26-30 EASTERN FRONTIER

A.P. 30 Eastern Promenade

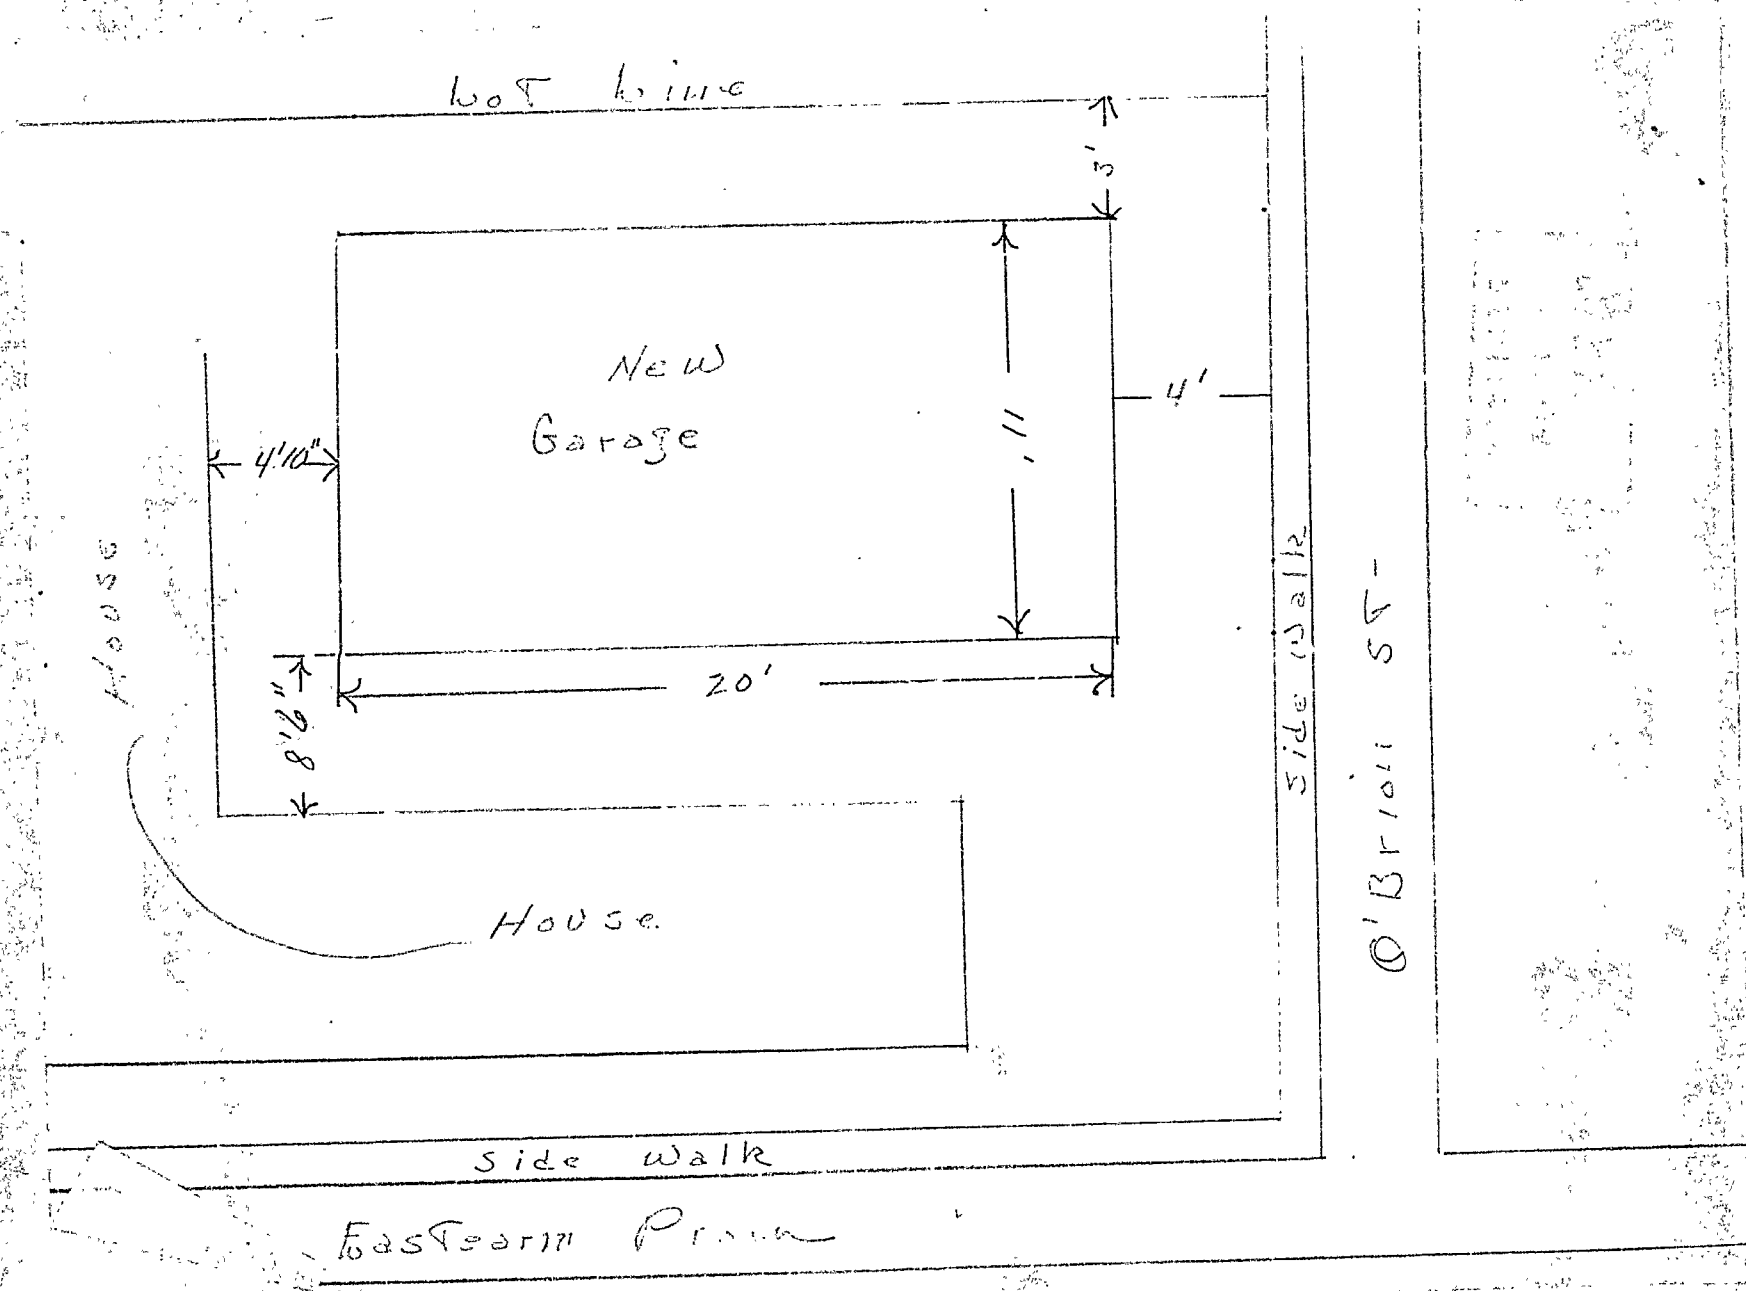
Building permit to demolish an existing metal frame garage 9 feet by 19 feet presently located on the property at the above named location and to construct a wood frame garage 11 feet by 20 feet in approximately the same location is not issuable under the Zoning Ordinance for the following reasons:

1. The front wall of the building is to be only about 4 feet from the line of O'Brien Street instead of the minimum setback on a side street of 10 feet specified by Section 14-F.
2. The side wall is to be only 3 feet from the rear lot line instead of the minimum of 5 feet required by Section 14-F because the building is to be closer than 50 feet to O'Brien Street.
3. The area of lot occupancy, which is already in excess of the 40 percent limit set by Section 7-B-6 of the Ordinance applying to the R-6 Residence Zone in which the property is located, will be slightly increased, thus increasing the non-conformity in that respect.
